APPLICATION NO.	FILING DATE	FIRST NAMED INVENTOR	ATTORNEY DOCKET NO.	CONFIRMATION NO.
10/644,902	08/21/2003	Cheng-Ming Yih	4425-315	6430

**Advisory Action**

Continuation of 10.

**Fig. 11B**

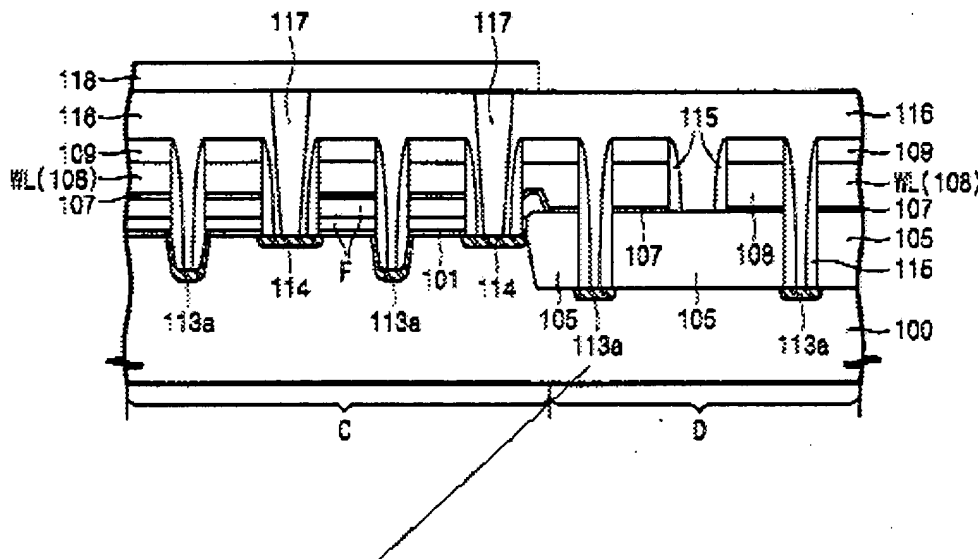
(1) Song discloses "a buried conductive region (113a, a source line buried into the substrate by impurity diffusion, column 5, lines 35-38) between said plurality of isolation regions (105).

Song's buried conductive region 113a is indeed under the isolation regions (105) as argued by Applicant, but is also **between** the isolation regions).

buried conductive region 113a is under and between isolation regions 105. In other words, one of ordinary skill in the art can **not** say that buried conductive region 113a is **not** between isolation regions 105.

As for the limitation "a depth of said buried source line is less than a depth of said plurality of isolation regions" as argued by Applicant, the limitation is not in the pertinent claims.

FIG. 2C

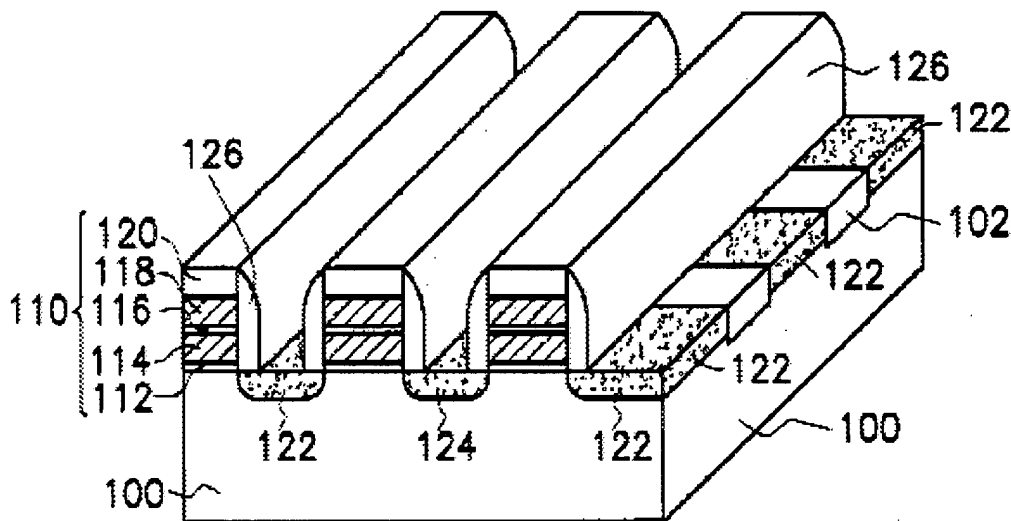
(2) In re the Lee reference, Applicant correctly argued that Lee's "[E]ach source array has a plurality of source regions 124 separately positioned between device isolation lines 102".

Therefore, if Lee's source region 124 is equivalent to the claimed buried **conductive region** (240), which is the case, and if Lee's device isolation lines 102 are equivalent to the claimed isolation regions (210), which is also the case, then Lee's buried conductive region 124 is separately positioned between device isolation regions 102, or in other words, a buried conductive region (124) between said plurality of isolation regions (102).

As for the argument that the depth of the source region can not be visually compared with that of the isolation region, since the depth of the source region (124) can be visually compared with that of the drain region (122), which as clearly depicted from Fig. 2C has a depth similar to that of source region 124 – reinforced by the general knowledge in the art that a source region and a drain region of a nonvolatile memory device have the same depth, which is the case of the Lee's reference, unless specifically formed differently, which is not the case with the Lee's reference) and since the depth of the drain region can be visually compared with that of the isolation region, the depth of the source region can be visually compared with that of the isolation region.
